FINAL DRAINAGE LETTER for CROSSROADS MIXED USE FILING NO. 1 UNDERGROUND DETENTION

EL PASO COUNTY, COLORADO

DECEMBER 2022

Please add "PCD File No. CDR-23-002"

**CROSSROADS MIXED USE FILING NO. 1
-PLAT**

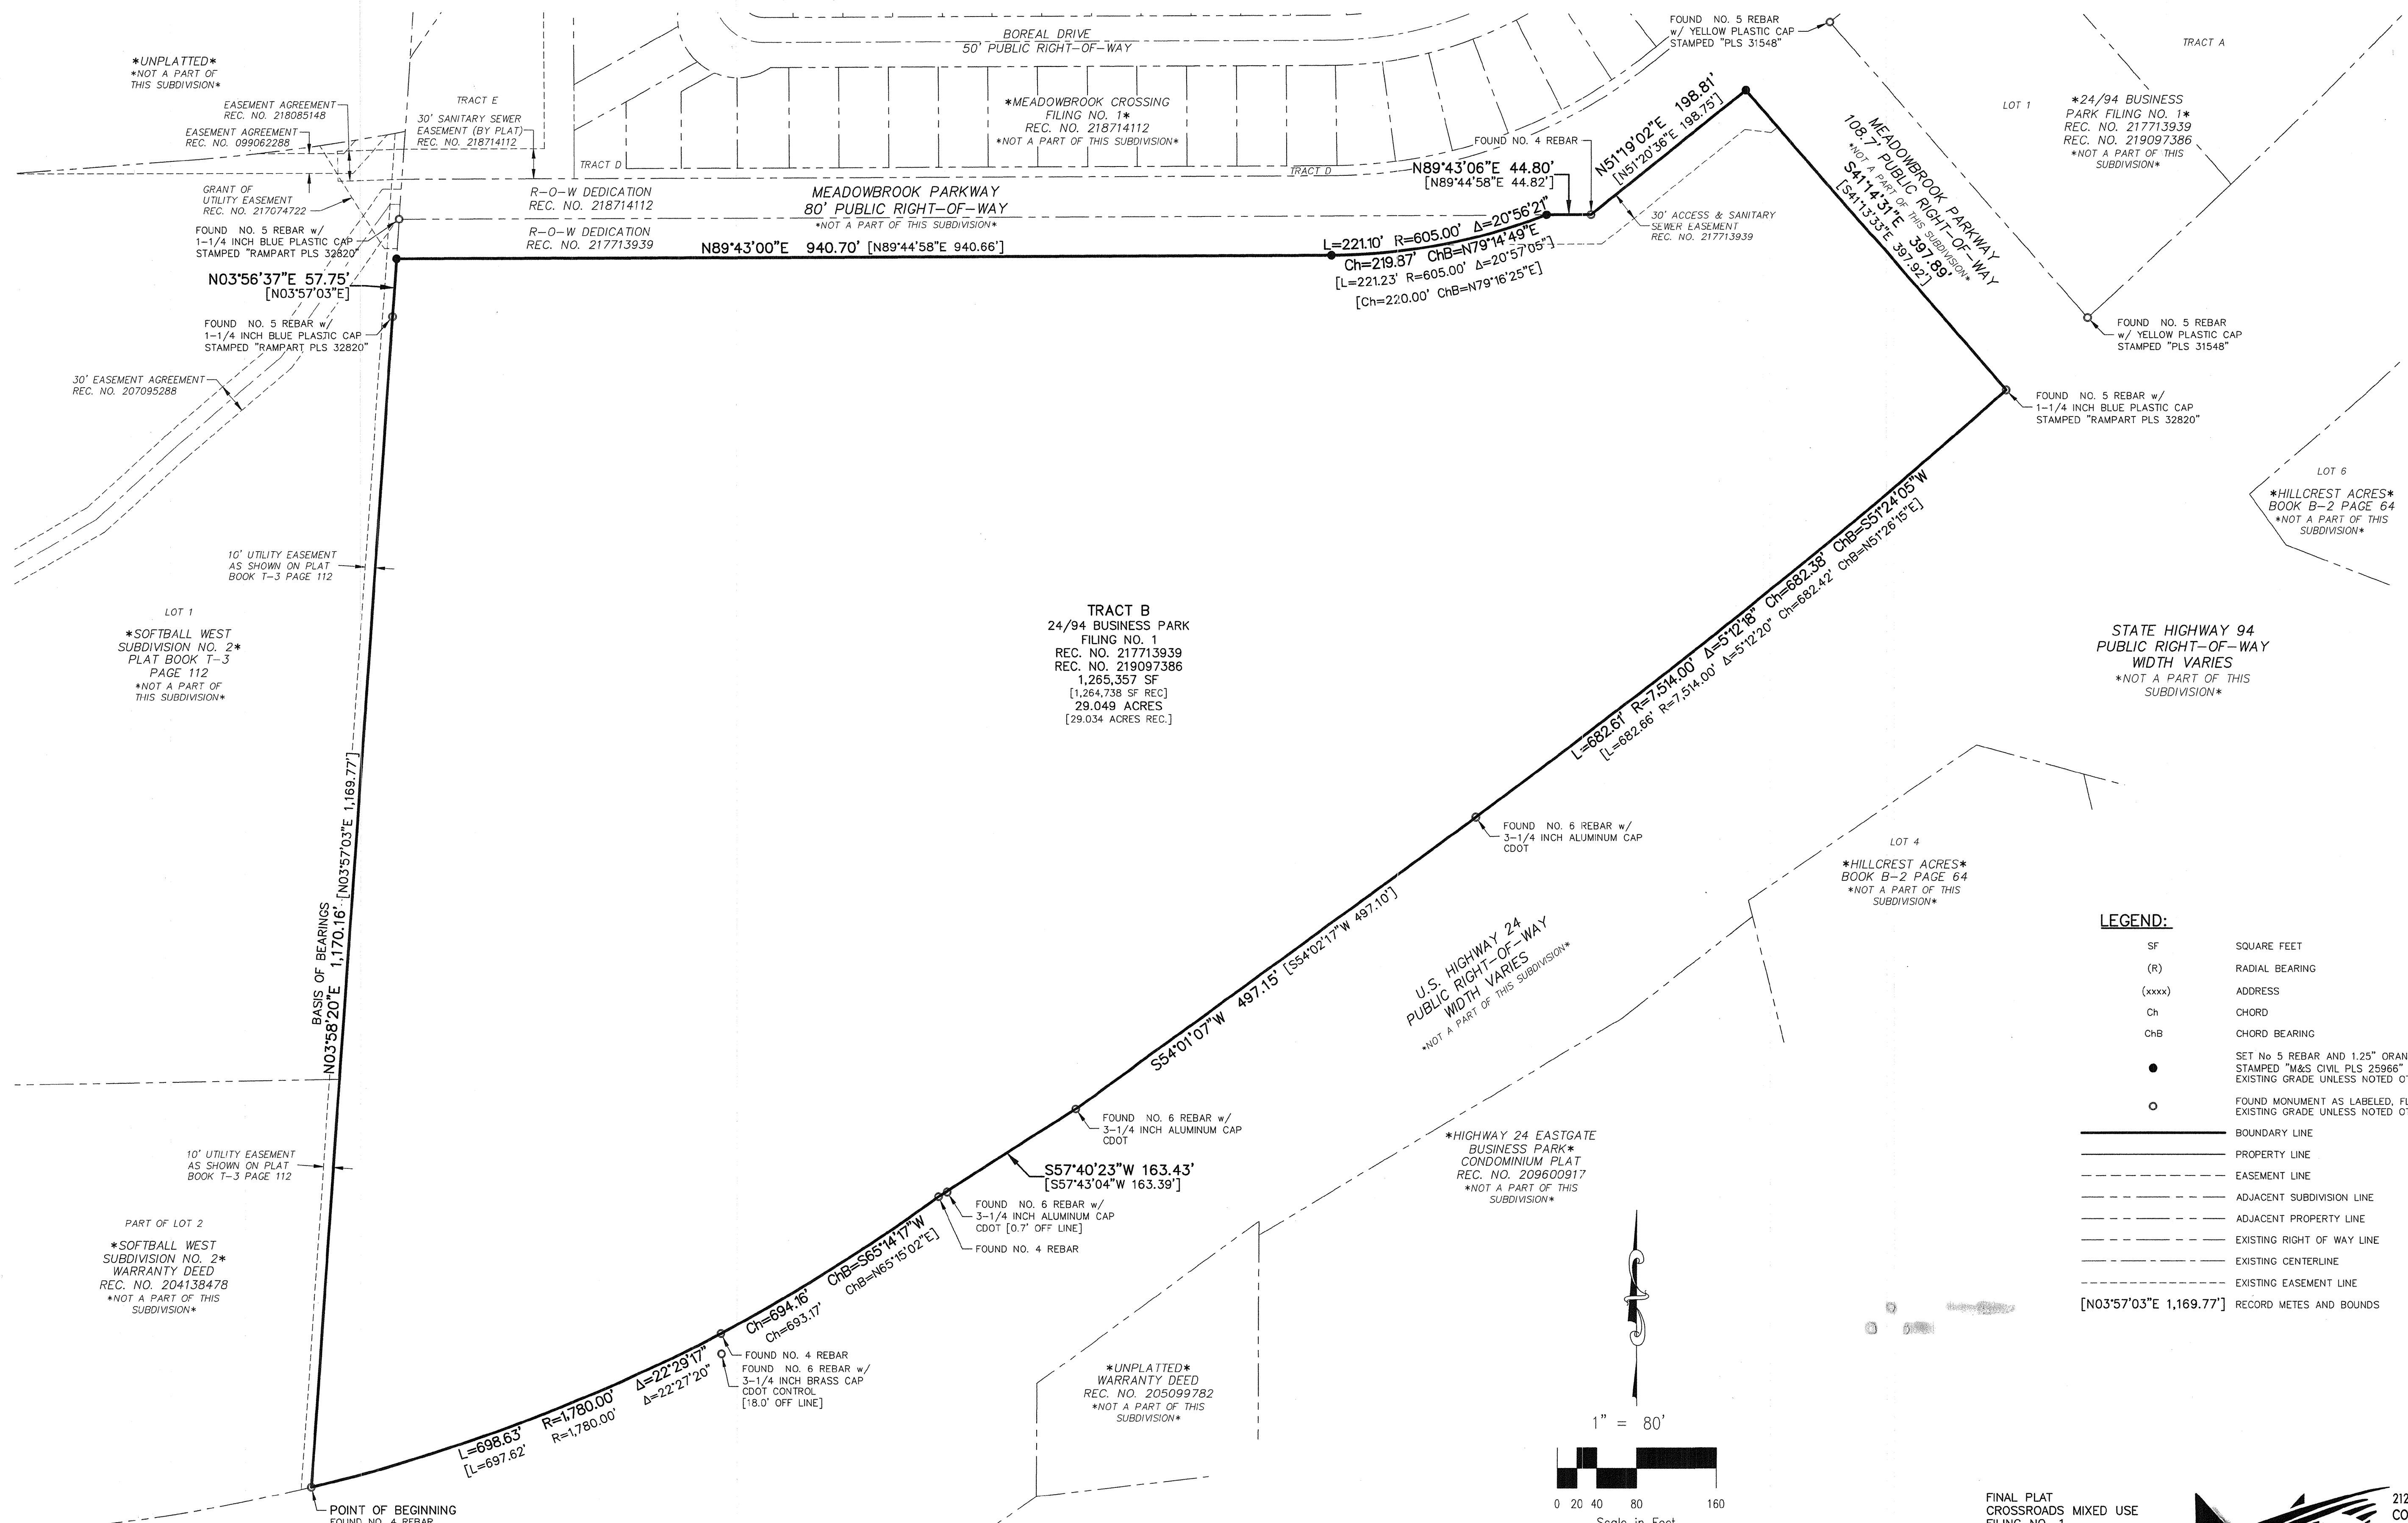
Remove Plat document.

CROSSROADS MIXED USE FILING NO. 1 FOR UNDERGROUND DETENTION (UGD) PROPOSED UGD CONDITIONS DRAINAGE MAP

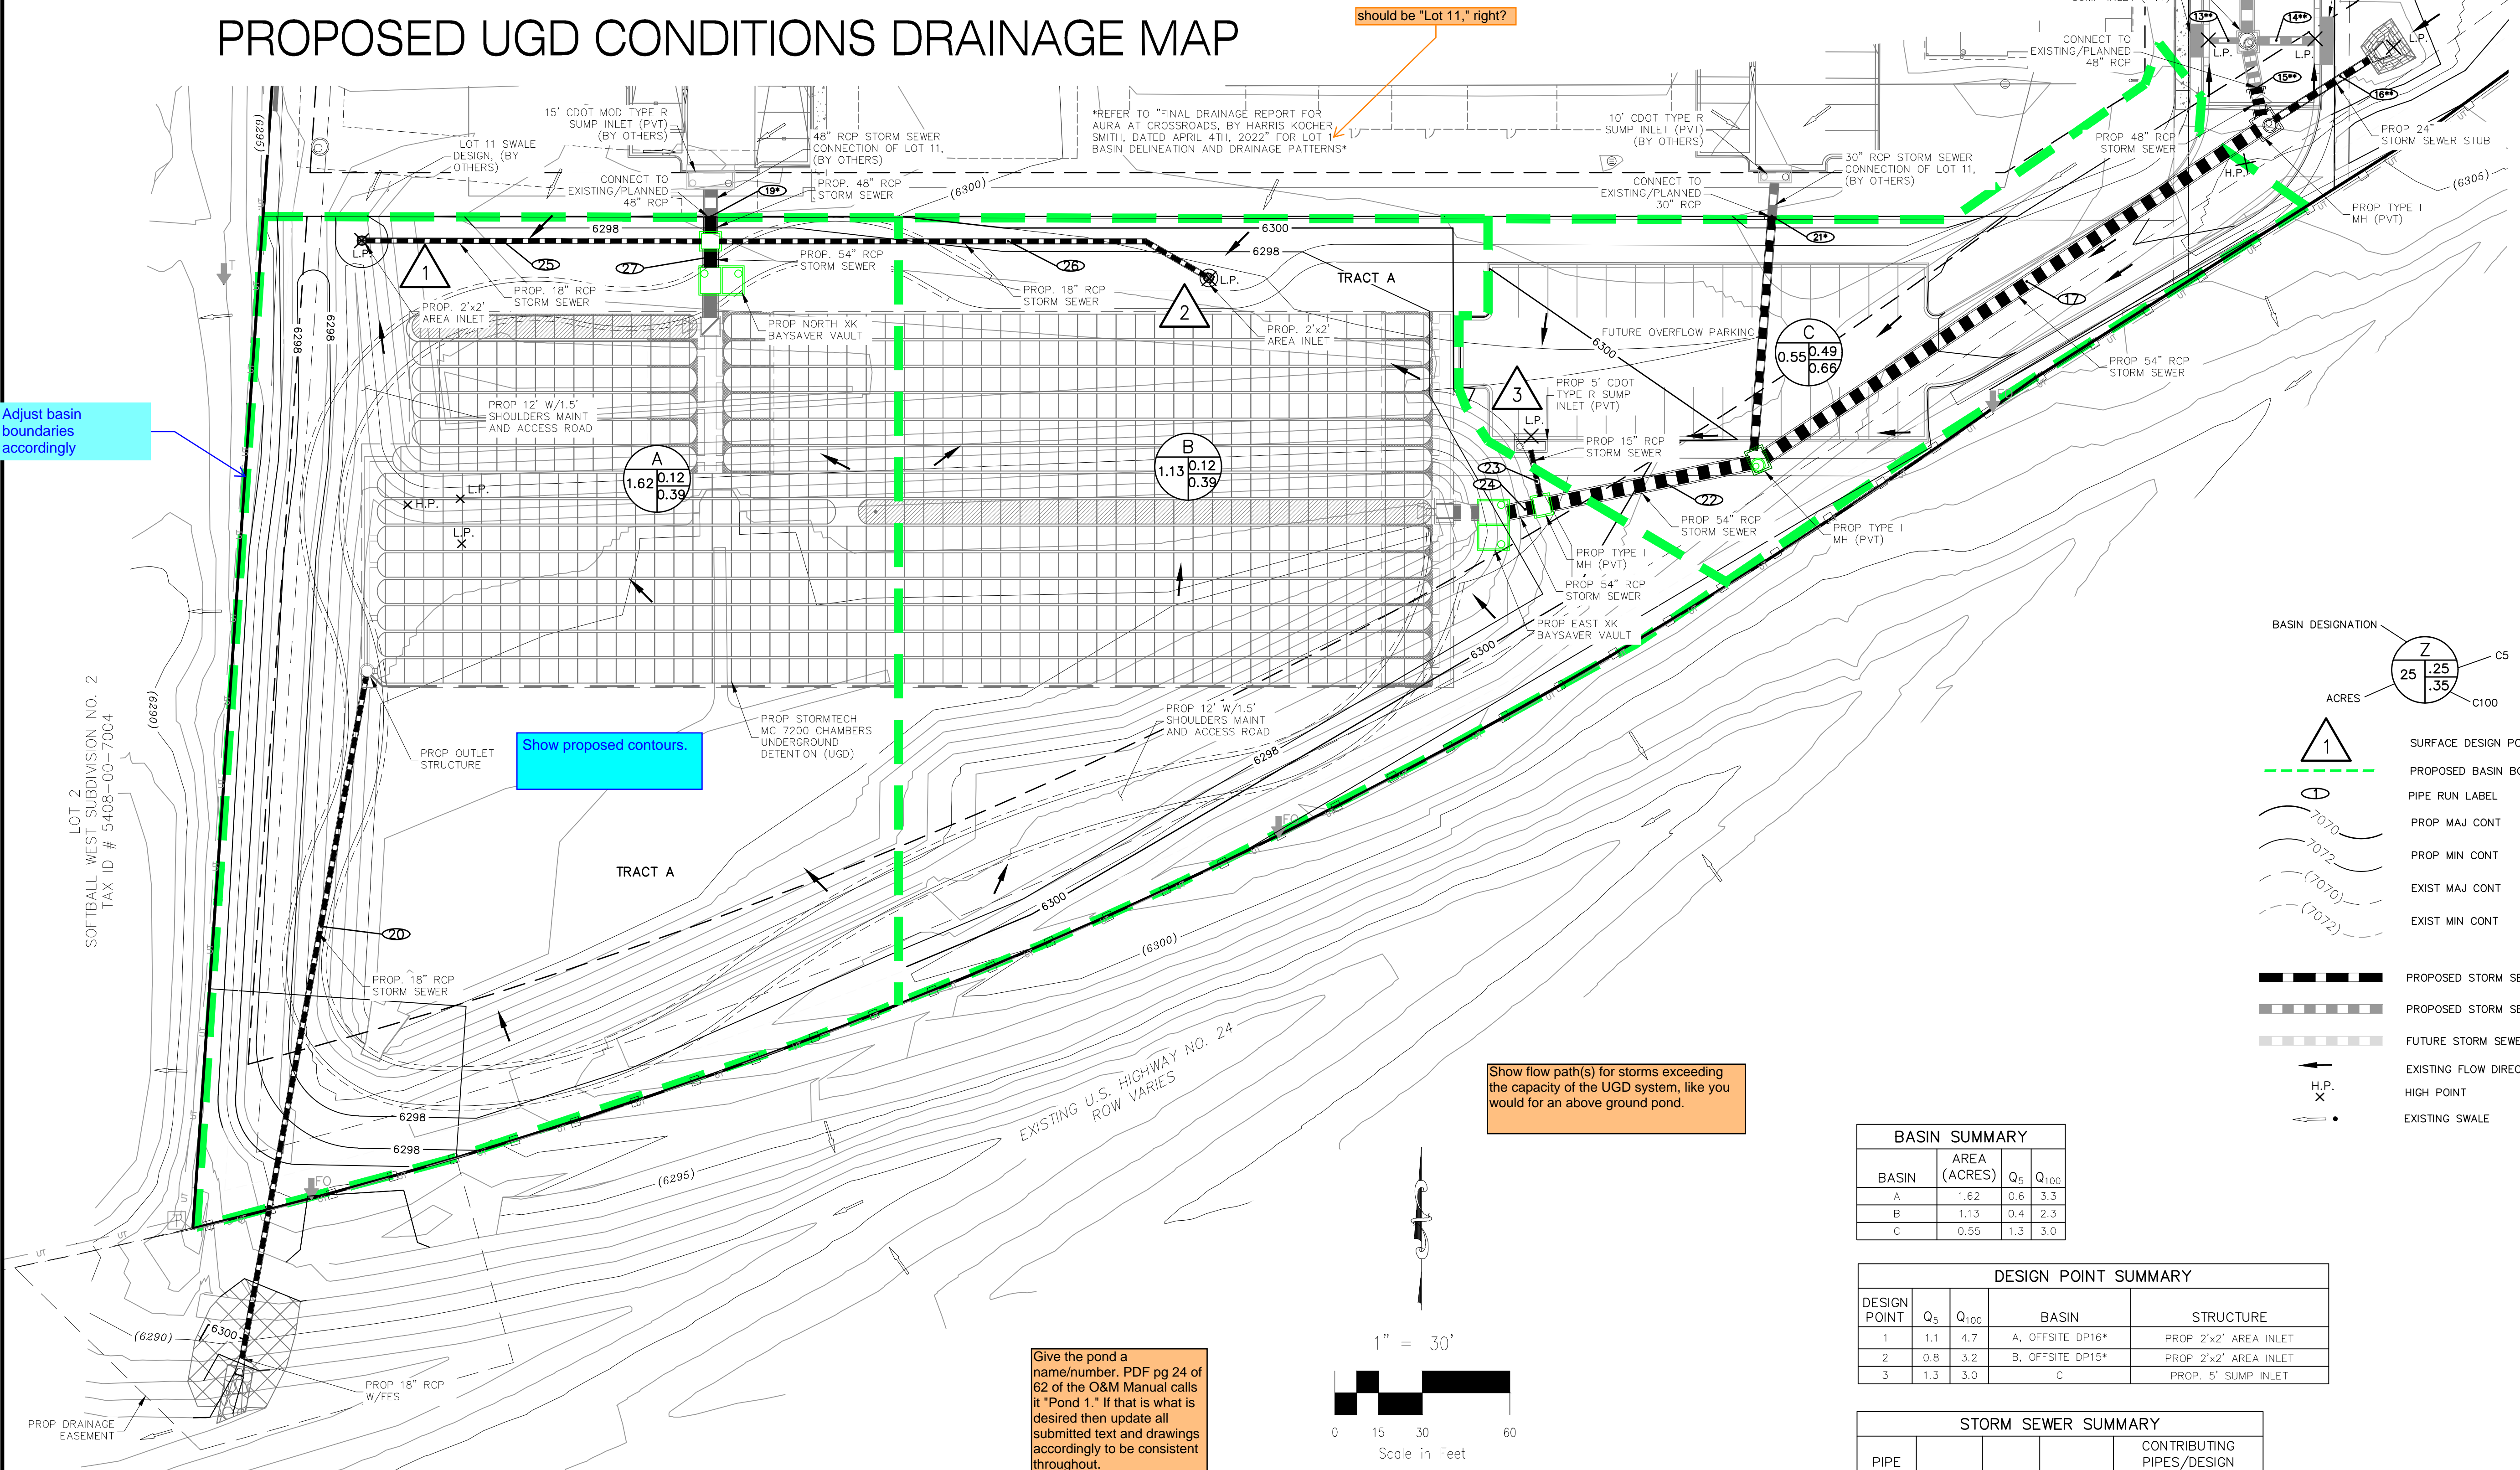
Adjust basin boundaries accordingly

Show proposed contours.

Show flow path(s) for storms exceeding the capacity of the UGD system, like you would for an above ground pond.
